COMMONWEALTH OF VIRGINIA
Department of Environmental Quality
Piedmont Regional Office

STATEMENT OF LEGAL AND FACTUAL BASIS

Hopewell Regional Wastewater Treatment Facility
Hopewell, Virginia
Permit No. PRO50735

FIGURE 1

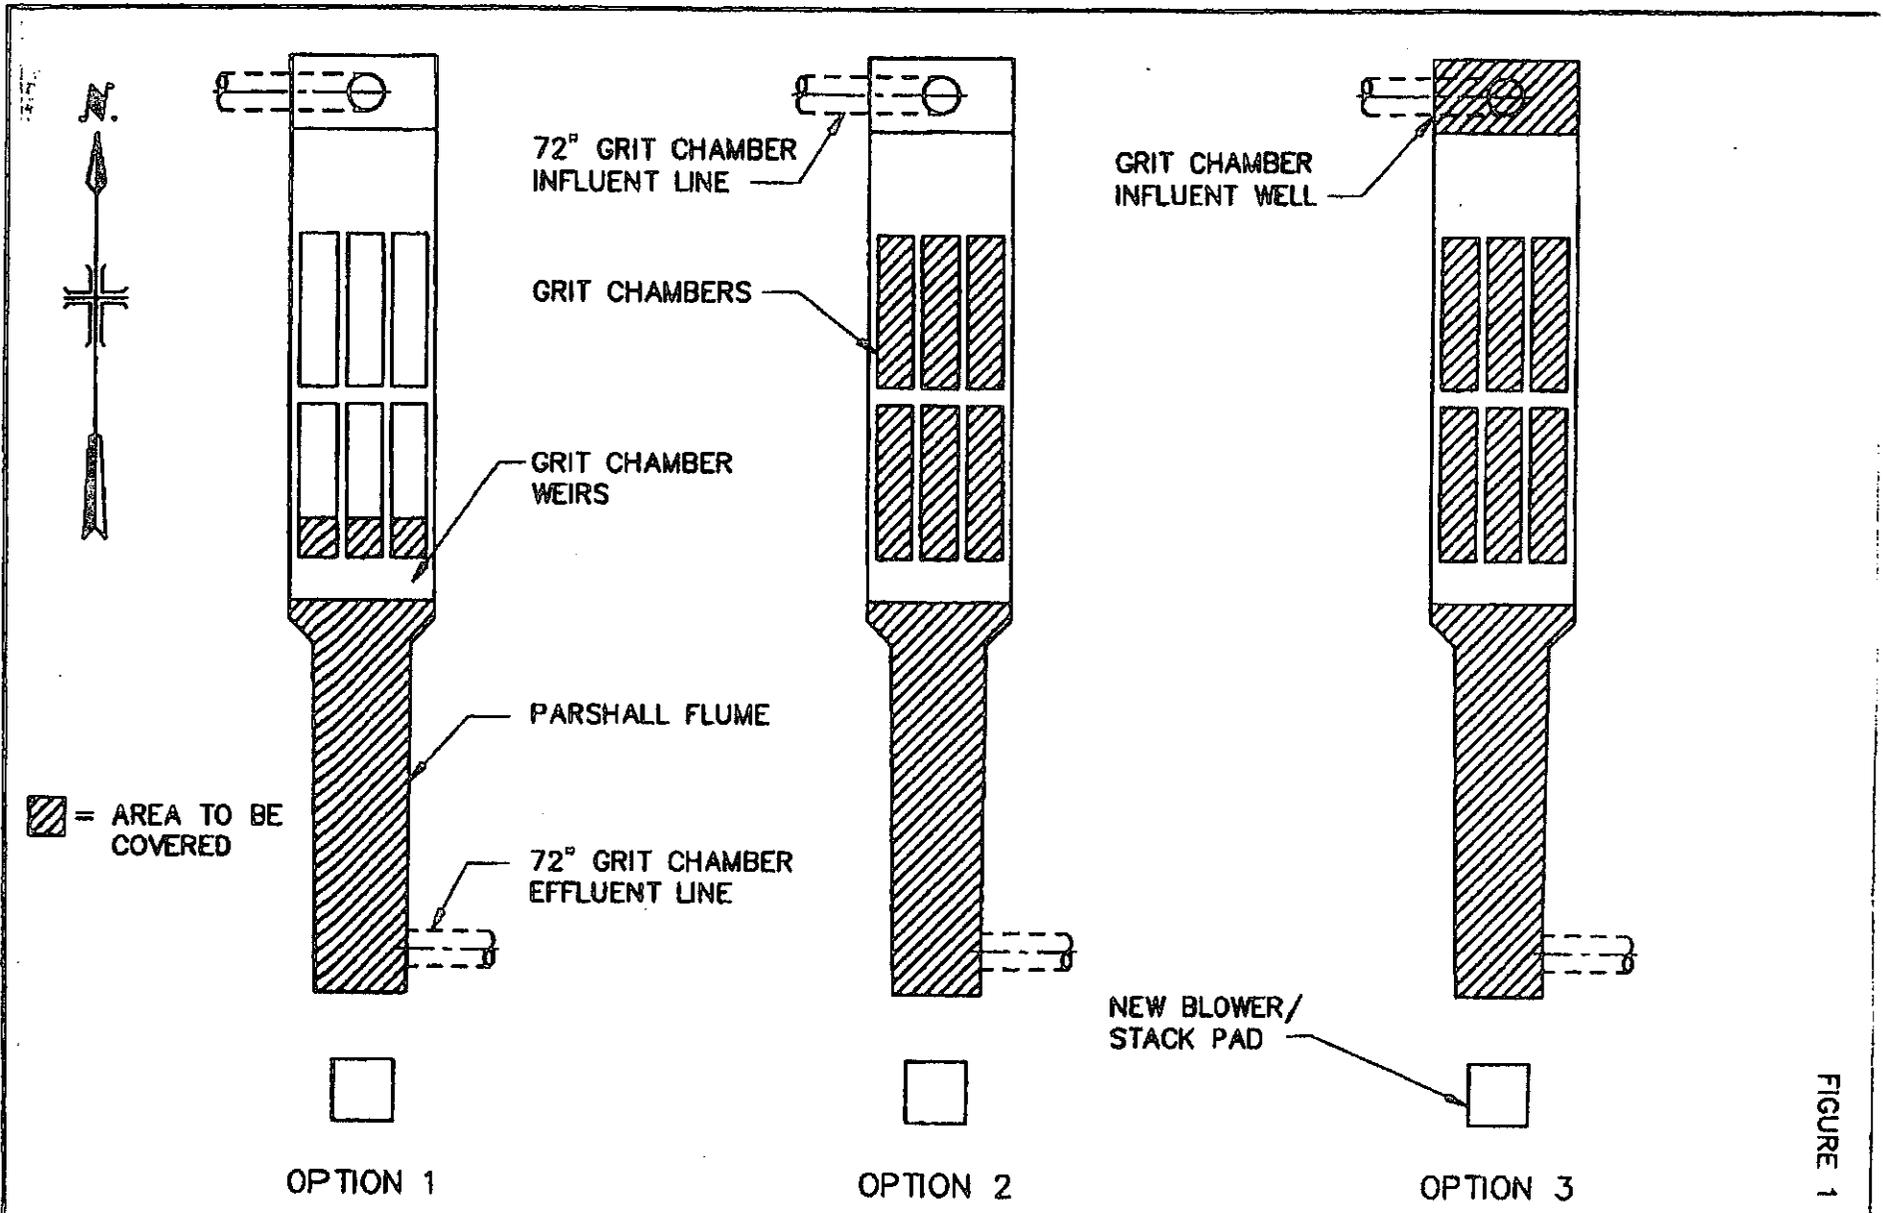
“The areas to be covered are the Grit Chamber Weirs (and the area surrounding the weirs) and the entire Parshall Flume basin as shown in Option 1 of Figure 1 in the April 1996 Technical Memorandum detailing VOC RACT cover options.”

This clarification is based on the three design options proposed to the facility in Malcolm Pirnie's April 24, 1996 Technical Memorandum for this requirement. Figure 1 of this document is attached which shows Options 1 – 3. The attached Table 2 of this document shows the projected cost of \$625,000 for Option 1 of which was stated in Hopewell Wastewater Regional Treatment Facility's April 24, 1996 letter to Dave Paylor of VA DEQ as follows:
